REMARKS

Amendments to the Drawings:

FIG. 1

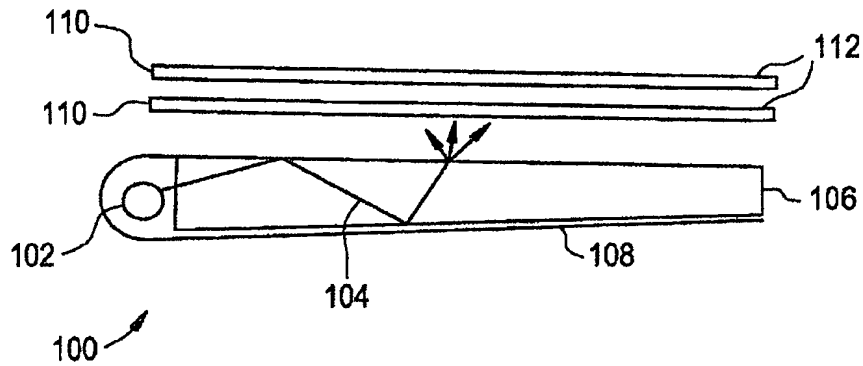
The drawings were objected to. Applicant has amended Figures 1 and 3 to include the coordinate r , and accordingly, applicant submits that the objection to the drawings has been overcome.

FIG. 3

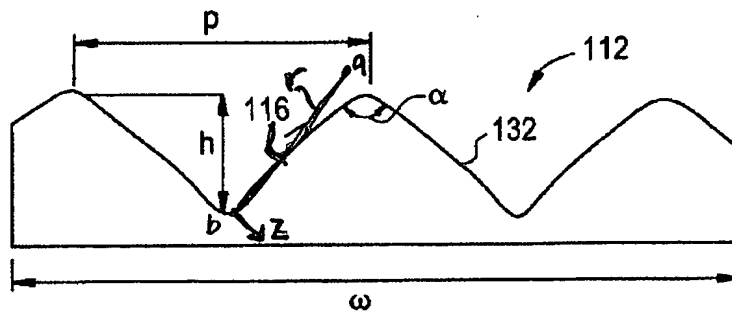
The specific changes which have been made to Figure 3 and 6 are to label the coordinate r on the drawings. Figure 3 has also been amended to label the points a and b , and the coordinate z .
